PROJECT: Epic Storage at Ann Road

CITY OF LAS VEGAS INTER-OFFICE MEMORANDUM			DATE: November 10, 2020
TO: Land Development Services Department of Building & Safety			FROM: Jennifer Shinn, P.E.  Flood Control, Engr. Associate Department of Public Works
SUBJECT:	Drainage Study for:		COPIES TO:
	Epic Storage at Ann Road		Horrocks Engineers
Cross Streets:	W Hammer Ln and N Shaumber Rd		Epic Development LLC
File Number:	F:\Depot\DSMemos\DS05314.doc		Bart Anderson, P.E., DevCo
Parcel Number:	126-36-101-017		CCPW CCRFCD
Zoning Action:	SDR-78449		
FEMA Flood Zone	YES	NO X	
Proposed Storm Drain	YES X	NO

ADDENDUM #1
TO THE
TECHNICAL DRAINAGE STUDY
FOR
EPIC STORAGE AT ANN ROAD
(APN 126-36-101-017)
IN
CITY OF LAS VEGAS, NEVADA

HORROCKS PROJECT NV-2108-1911

INTERIM CONDITIONS BASIN MAP

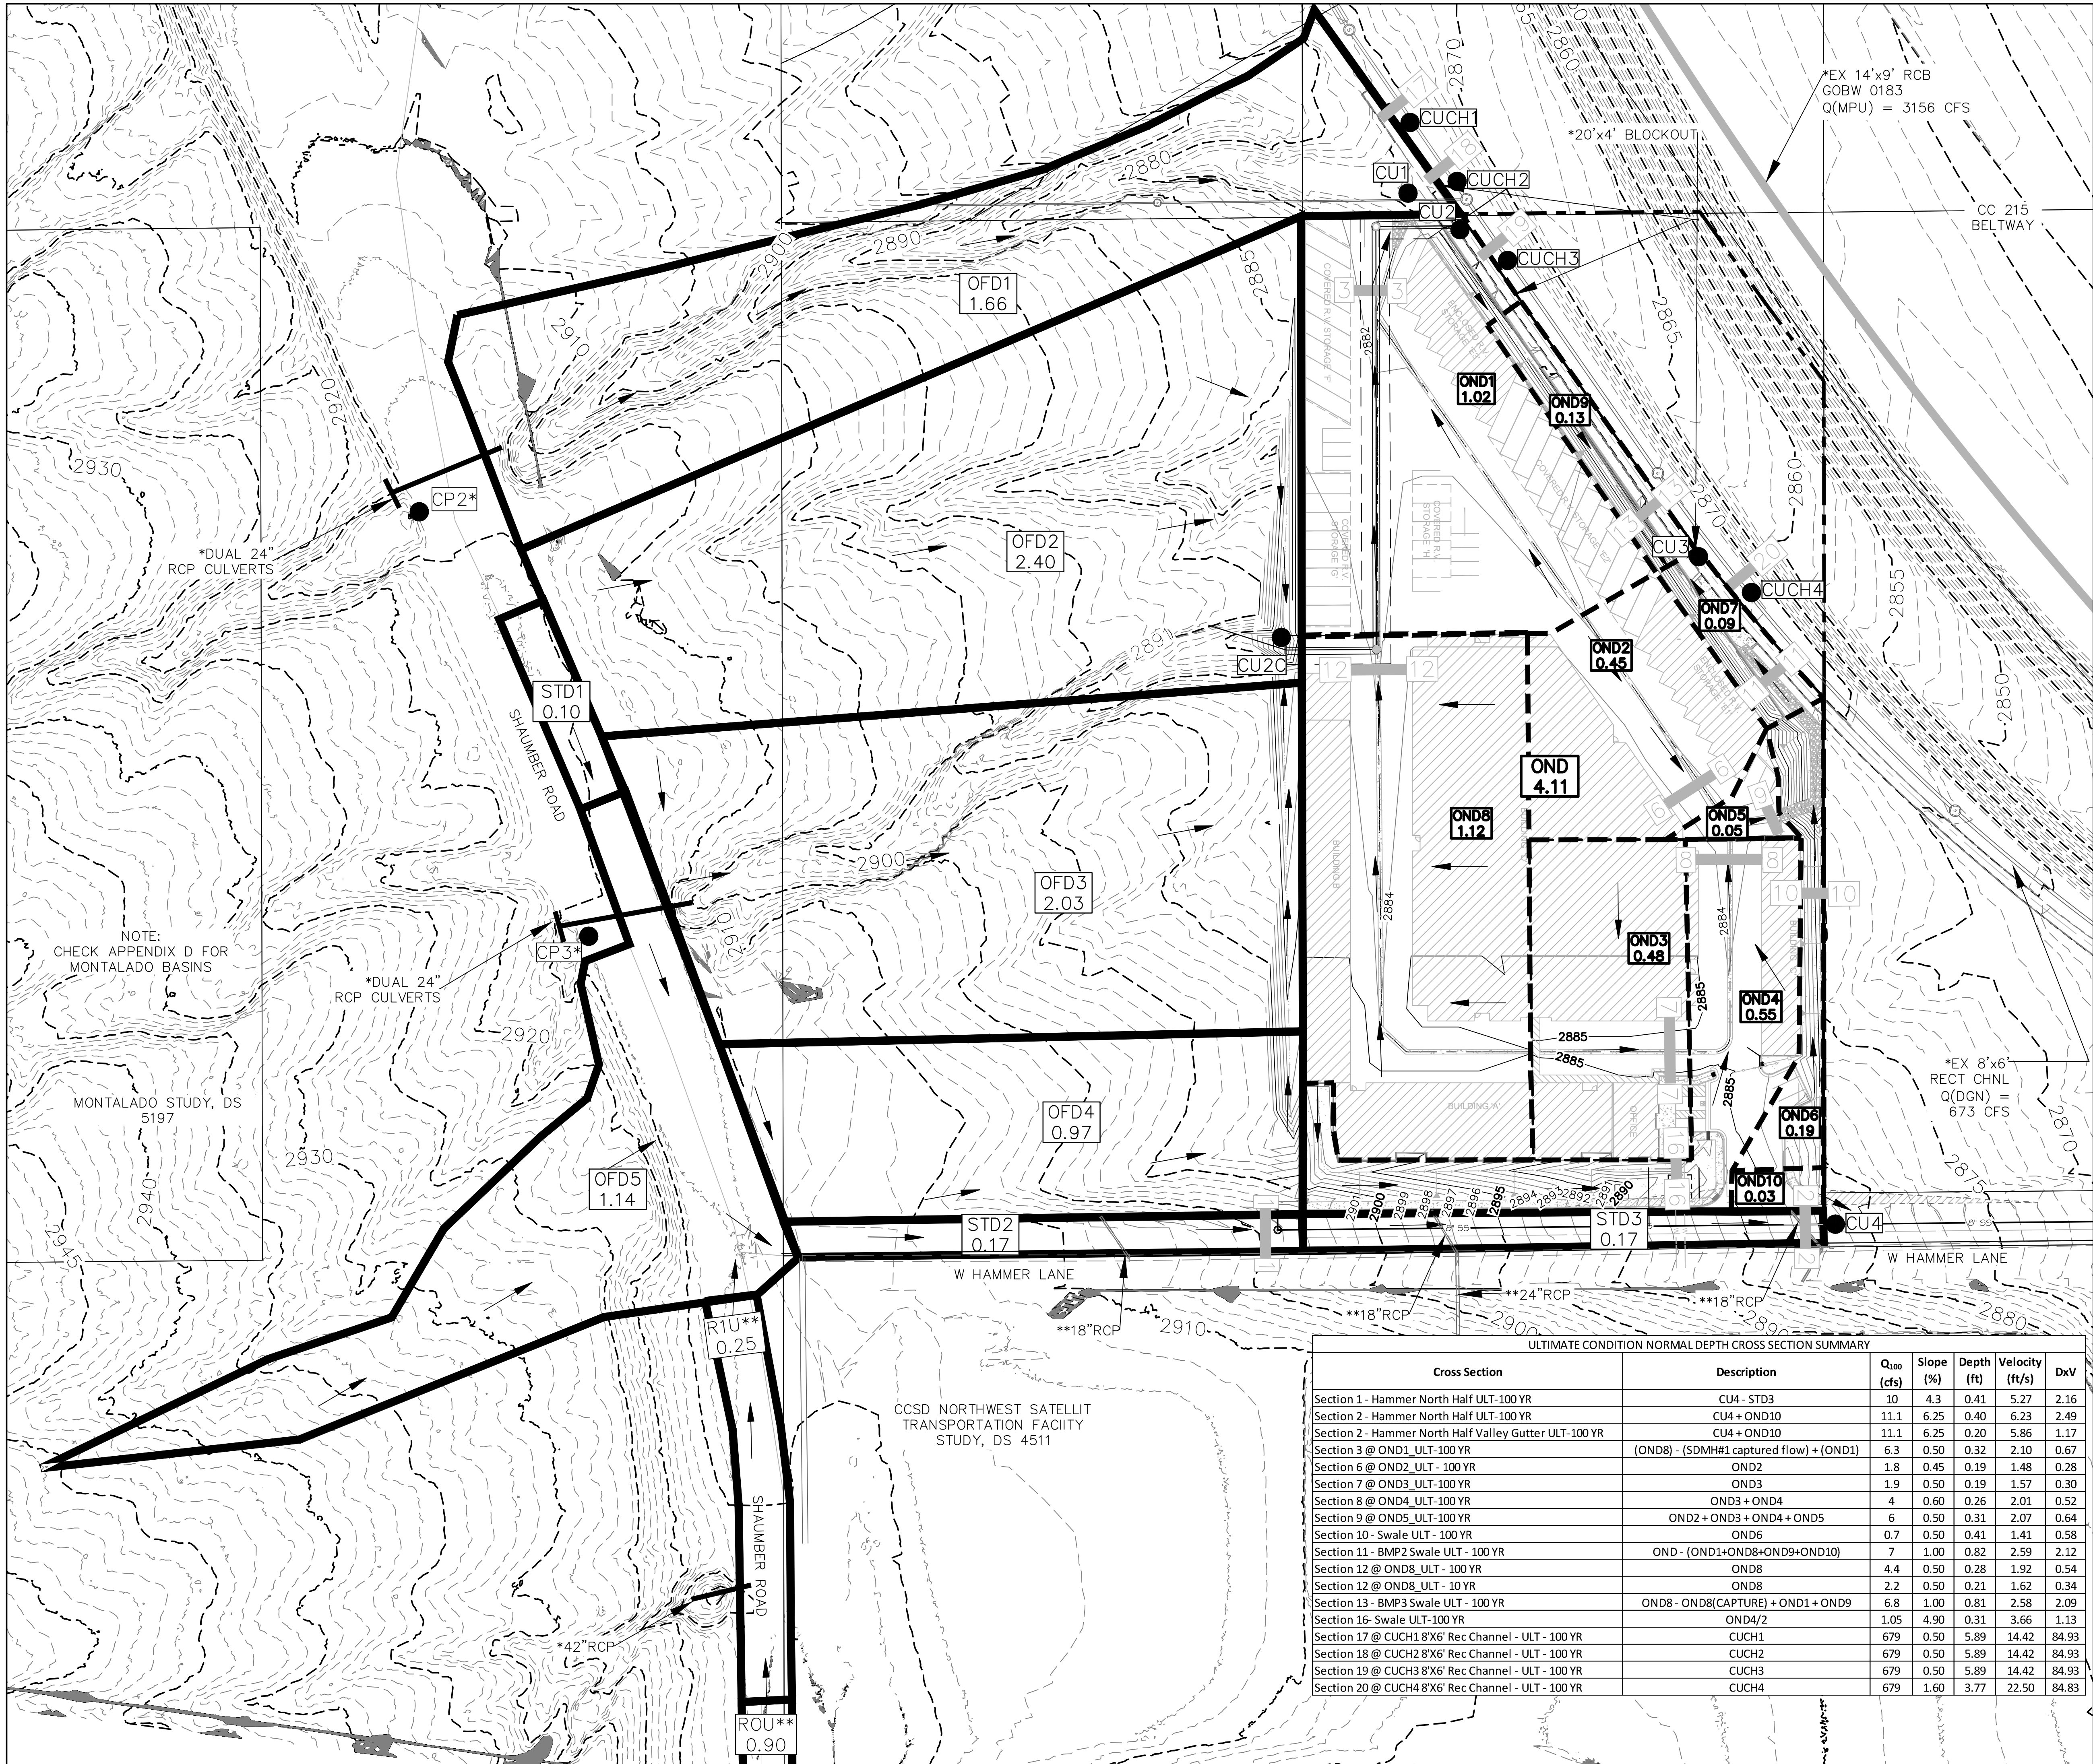
10. **Figure 6/7 Interim/Developed Conditions Map:** The location of CU2 is misleading. Per the grading sheets this combination point is not where the pipe and onsite flow discharges into the channel and the location of where the flow enters the channel is the location of the concrete pad.

11. **Figure 6/7 Interim/Developed Conditions Map:** Cross section 5 is showing 64.4 cfs within the onsite channel. It is unclear if that flow is outletting into the 8' channel at the location of the concrete pad, or if the flow is turning and entering into the onsite swale.

12. **Figure 6/7 Interim/Developed Conditions Map:** The onsite swale directing flow through the BMP at the east edge of the site near the 215 is shown to flow northwest on these exhibits, but flows southeast on the grading plans. Revise accordingly.

RESPONSE: The location of CI2/CU2 has been revised to show the correct location where runoff is discharged into the channel via the storm drain. Revised Drainage Figures 6 and 7 can be found in Appendix A.

RESPONSE: The design has been revised since the original submittal to discharge from the storm drain pipe directly into the existing 8' wide concrete channel. Section 5 has been removed from the analysis and this swale is replaced with section 13. The intent is that the bypass runoff from OND8, basins OND1 and OND9 are conveyed to the southern blockout west of the proposed retaining wall. Near the existing southern 20'x4' blockout at CI3/CU3 the runoff is collected with a beehive inlet and discharged to combine with the runoff from the swale conveyed from the south and then into the existing channel through the blockout. Both BMP swales have been revised to this location. The WSPG model has been revised and is included in Appendix C. See Figures 7 and 8 for the normal depth calculations summary information, flow patterns and peak flowrates.

RESPONSE: The grading plans and revised figures now agree on the direction of the drainage swale. The site discharge at the 20'x4' blockout of the western wall of the existing 8' wide concrete channel. See Figure 8 for BMP calculations. See Appendix A and D for the revised figures and grading plans, respectively.

BMP FIGURE

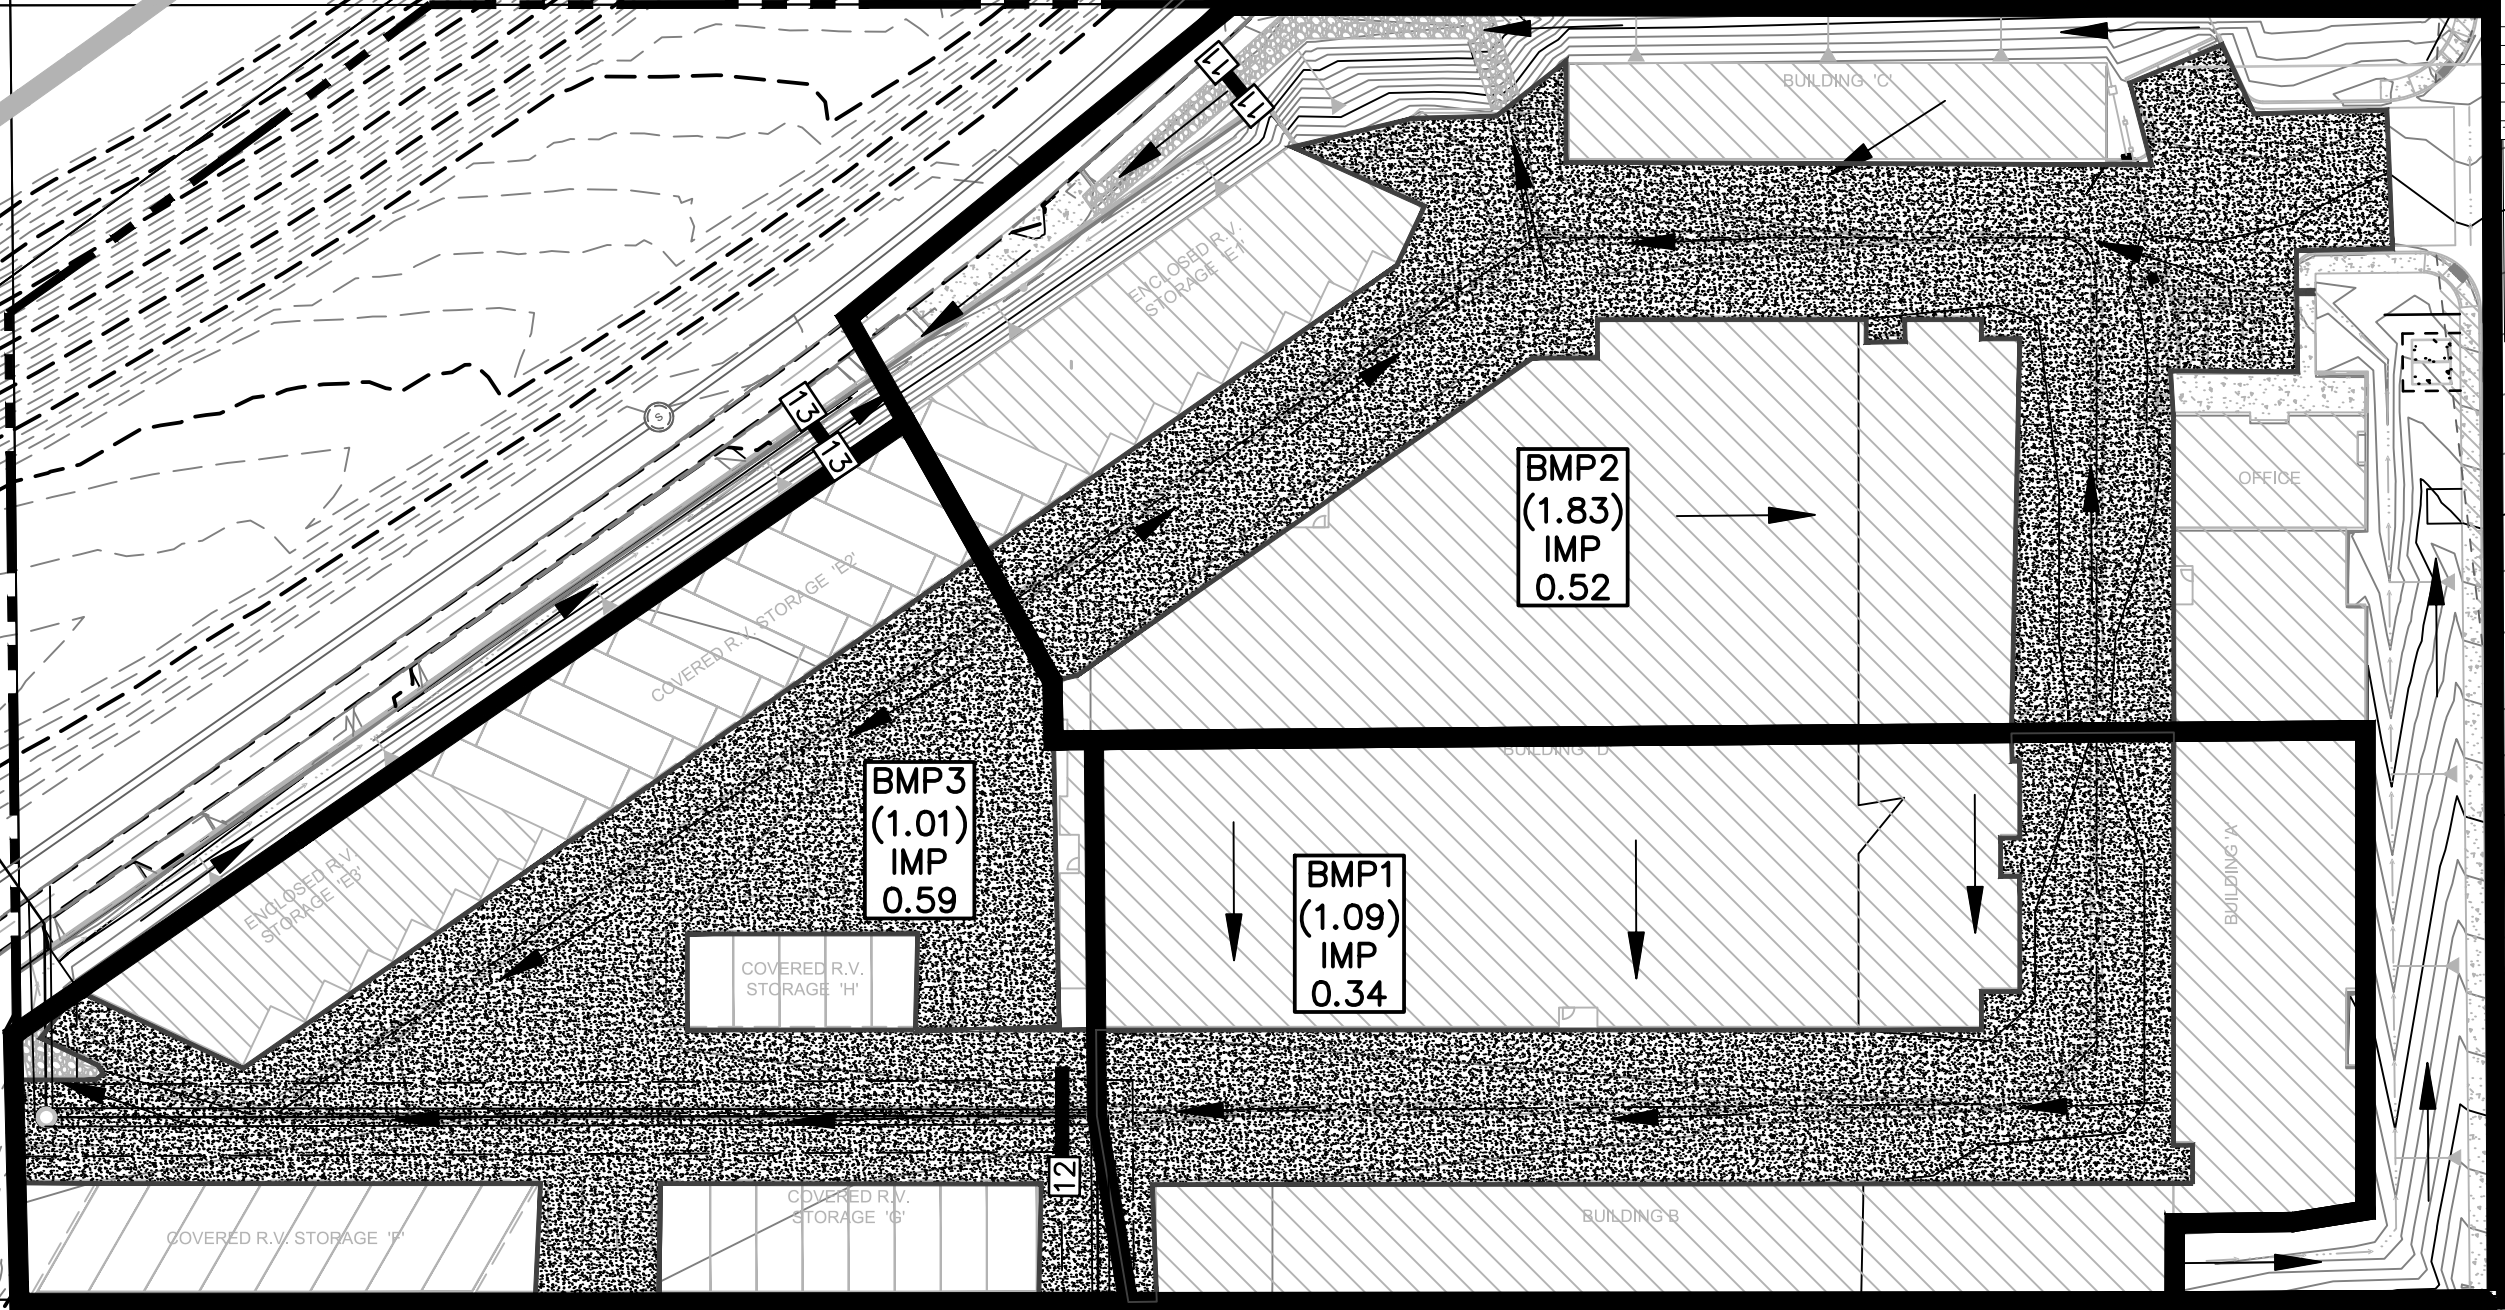
17. Provide BMP calculations that meet the requirements laid out in the HCDDM. Per section 1502.2 the site is categorized as having a large parking lot

RESPONSE: The BMP calculations are included in Appendix C to clarify and show that the site design meets the criteria of Section 1502.2 for a large parking lot. Figure 8 has been revised and shows that the site will treat over 75% of the impervious area and can be found in Appendix A. Hydraulic calculations for the BMPs swales (section 13 and 11) can be found in Appendix C.
